October 18, 2022

SUBJECT: Notice of Approval with Conditions of the Work Plan – Final Remedy for the House Street Property as Required by the Wolverine World Wide, Inc.  
Consent Decree Court Case No. 1:18-cv-00039

The Michigan Department of Environment, Great Lakes and Energy (EGLE), Remediation and Redevelopment Division, has reviewed the Revised Work Plan – Final Remedy for the House Street Property (Work Plan) located at 1855 House Street, Plainfield Township, Michigan. The original Work Plan was submitted on April 26, 2022, and subsequently updated to include some missing pages on May 26, 2022.

**6. Gas Management Plan & Landfill Gas Migration Monitoring Plan (Appendix B – Page 122 & 123)**

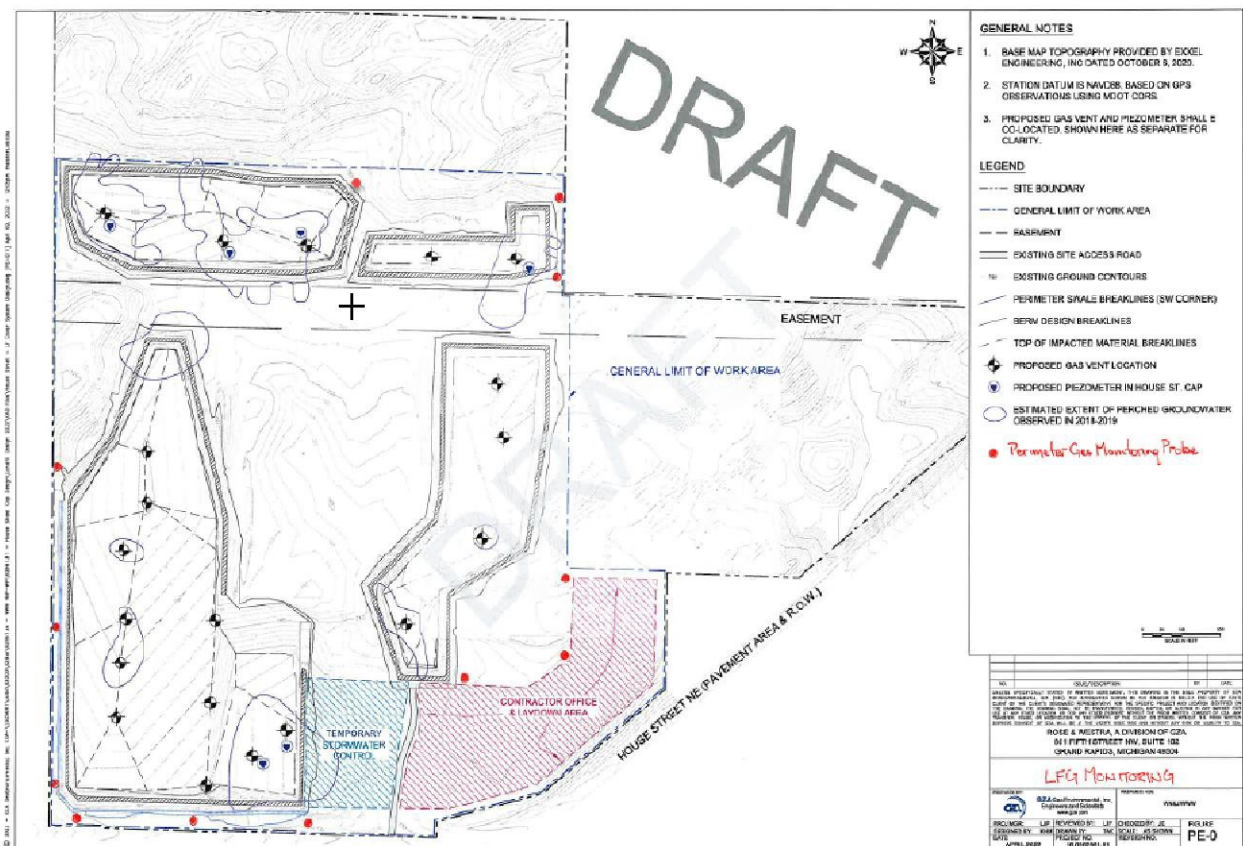
- a. It is understood that the post-construction plan submitted to EGLE for approval after completion of the project will include details of the landfill gas monitoring, which will be part of the long-term operations and maintenance and monitoring of the site. Please make a note in the appropriate sections of the Work Plan that the Landfill gas migration monitoring plan will generally consist of the following:

- i. Monitoring will be conducted on a quarterly basis to confirm that methane gas, if generated, is not more than 100 percent of the lower explosive limit at gas vents and perimeter gas probes; that the concentration of methane gas is not more than the lower explosive limit at House Street Property boundary; and gases, generated, if any, do not create a nuisance odor at the House Street Property Boundary.
- ii. Mitigation steps and remedial measures if methane gas levels exceed the limits specified in the approved LFG monitoring plan and post-closure plan.
- iii. Include a figure that identifies the conceptual locations of perimeter landfill gas monitoring points as shown below (12 red points):

**21. Figure PE-021:**

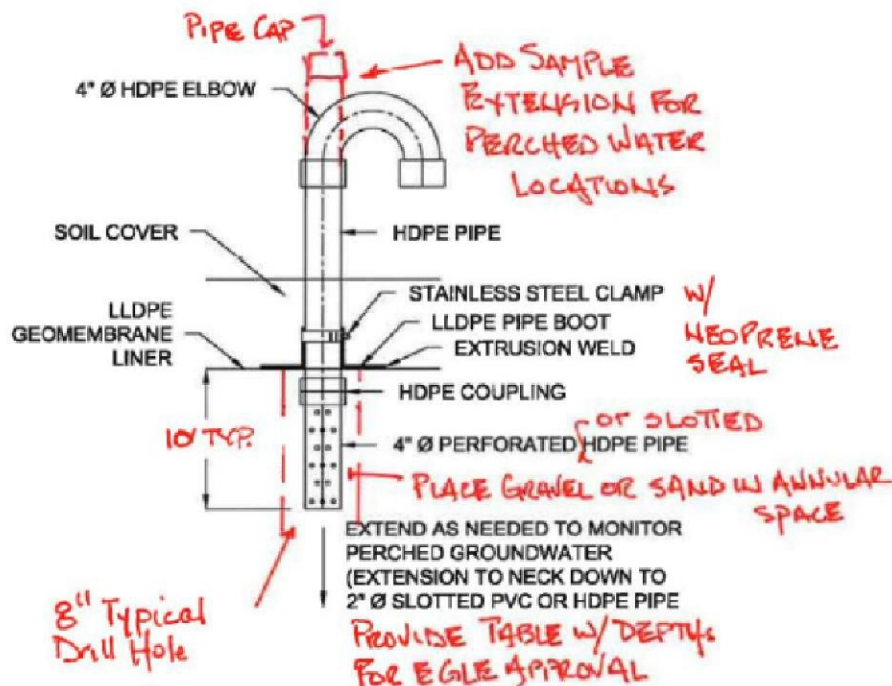
- a. Please update the Landfill gas vent detail as shown below:

- b. Additionally, in the corresponding part of the Work Plan text, clarify that the LLDPE subgrade and/or material placed as top-of-subgrade will be tested for permeability and the surface will be tracked or rolled but not compacted with vibration. A rough calculation of the necessary standard for the permeability of the gas venting layer should be included. The specifications for this layer should include appropriate permeability testing to ensure that it meets the required/calculated permeability and grain size analysis to ensure it meets the requirements of Rule 918(5)(c).
